# UNITED STATES PATENT AND TRADEMARK OFFICE

APPLICATION NO.	FILING DATE	FIRST NAMED INVENTOR	ATTORNEY DOCKET NO.	CONFIRMATION NO.
10/551,624	06/26/2006	Stephane Moreau	17102/023001	5504

<b>Office Action Summary</b>	<b>Application No.</b> 10/551,624	<b>Applicant(s)</b> MOREAU ET AL.	
	<b>Examiner</b> ALEXANDER B. COMLEY	<b>Art Unit</b> 3746

FIG. 3

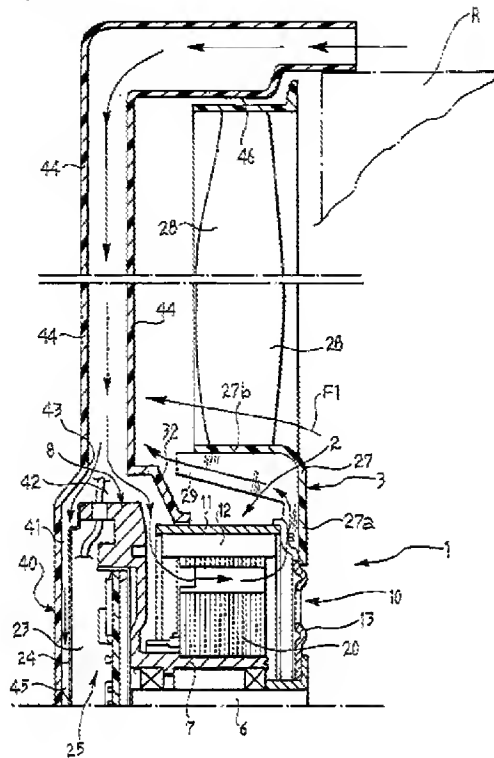
In regards to Independent **Claim 1**, and with particular reference to Figure 3 shown immediately above, Avidano discloses:

A ventilation device (1) comprising a fan (3) capable of being driven rotationally by an open electric motor (2) which is firmly attached to a support (40) intended for fixing said ventilation device (1), the fan (3) consisting of a plurality of blades (28) which are distributed regularly around a bowl (27) inside which there are arranged internal ribs (29) capable of ventilating said open electric motor (2), characterized in that the support (40) comprises a central part (24, 32) which is connected in a substantially sealed manner to at least one peripheral portion (11) of the open electric motor (2).

As shown in Figure 3 above, Avidano et al. discloses an electric motor-driven fan

unit for use in motor vehicles. Avidano's fan is designed with a hub and airflow structure that allows the fan's internal blades to cool the motor. In particular, Avidano states "A motor-driven fan includes an electric motor including a rotor and a stator in which the rotor includes an essentially cup-shaped cap which extends at least partly around the stator and has a plurality of lateral exit openings adjacent the bottom wall, and an impeller or fan including a hollow hub from which extends a plurality of main outer fan blades. This hub has a front wall fixed to the back wall of the cap of the rotor and a lateral skirt which surrounds the lateral wall of the cap in a radially spaced relationship. The hub is further provided with inner ventilation blades acting in operation to generate a cooling air stream which passes through the motor." (Abstract) Moreover, Avidano specifically describes the hub structure of Applicant's claimed invention by stating "The fan or rotor 3 of the motor-driven fan comprises a hollow hub 27 (FIG. 1) from which extends a plurality of main outer fan blades 28. The hub 27 has a front wall 27a fixed to the radial projections 15 of the disc element 13 of the cap 10, by means of rivets 29 or the like (FIG. 1). The hub 27 of the fan 3 further has a lateral, essentially cylindrical, skirt 27b which surrounds the side wall or ring 11 of the cap 10 in a radially spaced relation thereto. As is seen in FIG. 1, the hub 27 of the fan 3 is further provided, in the space 30 defined between the ring 11 of the cap 10 and the skirt 27b of the hub of the fan with internal fan blades 29 which extend in respective inclined planes with respect to the radial direction." (Column 2, Lines 36-48) Avidano goes on to disclose a main support body 40 with a central support 32 that serves to seal the open electric motor within the support. In particular, Avidano states "In the embodiment of FIG. 3 a

rear body 40 is fixed to the stator body 8 on the side opposite the fan 3, which extends in facing and spaced relationship with respect to the cover 24 and which surrounds the periphery of the stator body 8 lying close the annular separator element 32.” (Column 3, Lines 42-45) As can be seen in Figure 3, the annular separator provides a sealed pathway directing the airflow upward and outward towards the rotating fan blades.

5. In regards to dependent **Claims 2-5 & 15**, the annular separator element 32 surrounds and holds the outer periphery of the motor element 2. Moreover, it can be seen in Figure 3 that the inner edge of separator element 32 cooperates with the annular wall of the motor in a continuous, contiguous fashion, while the cover 24 cooperates with the rear portion of the motor. In particular, Avidano states “The portion of the rear body 40 facing the cover 24 of the stator is conveniently provided with at least one projection 45 in contact with this cover for the purpose of reducing or cancelling the effects of vibration.” (Column 3, Lines 52-55) In regards to dependent **Claims 6-10**, it can be seen in Figure 3 that a blind hole, which surrounds and holds the rear portion of the electric motor, is formed between the annular separator element 32 and the cover 24. This opening (or hole) is attached to the rear part of the motor by tight fitting, and forms a plate around the rear portion of the motor. Regarding dependent **Claims 11-14**, the annular separator element 32 forms a surface opposite the bottom of the hub (i.e. bowl) that directs airflow from the inside of the hub to the outside of the hub (See Figure 3). Moreover, the separator has a concave shape (a quarter of a circle) that is flat, extends discontinuously (as its contour changes), and
